Los Angeles
Department of
Water & Power

SUBJECT: Adoption of the Interim Remedial Action Decision, North Hollywood West Well Field

**INTERIM REMEDIAL ACTION DECISION
NORTH HOLLYWOOD WEST WELL FIELD**

NHW IRAD
APPENDIX A
DETAILED RESPONSES TO COMMENTS

Figure 1: Simulated hydraulic head distribution in the A-Zone within the NHW transport model domain at the end of the AMEC historical model and observed water level data from the EPA database

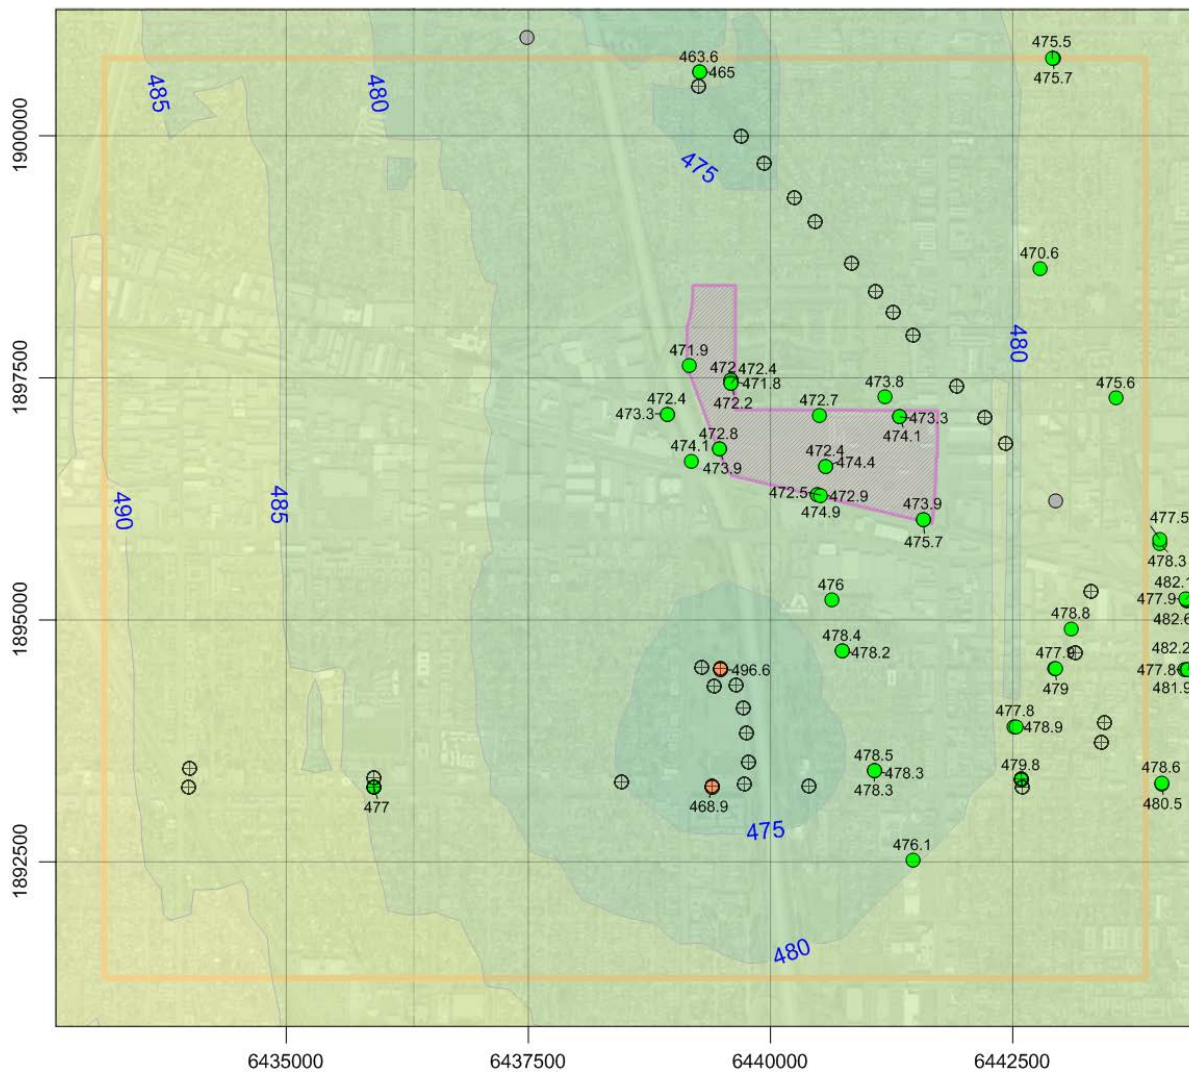
The North Hollywood West well field is outside of the NHOU investigation area (as can be seen in RI/FS Figure 1-1). The AMEC Groundwater Modeling Memorandum (2015) states that the groundwater model was extrapolated outside the investigation area (p. 1, 79). The model used to investigate remediation options for the well field should be constructed to best represent the well field — not extrapolated from the regional model. The AMEC (2015) model was calibrated to groundwater heads and water flux, but not contaminant distributions. The AMEC Groundwater Modeling Memorandum states that the model is not a unique representation of the SFB (p. ES-8). There is no evidence provided in the LADWP RI/FS document or appendices

In addition, LADWP has reviewed recent groundwater level data measured in the vicinity of Hewitt Site and NHW Well Field from the EPA database and compared this to the simulated groundwater levels from the calibrated AMEC model. Figure 1 of this Detailed Responses to Comment document presents the simulated hydraulic head distribution in the A-Zone within the NHW transport model domain at the end of the calibration period (this simulated head distribution was used for initial conditions in the forecast model which starts October 1, 2015). Figure 1 also presents the observed water level data from the EPA database using the following methodology and assumptions:
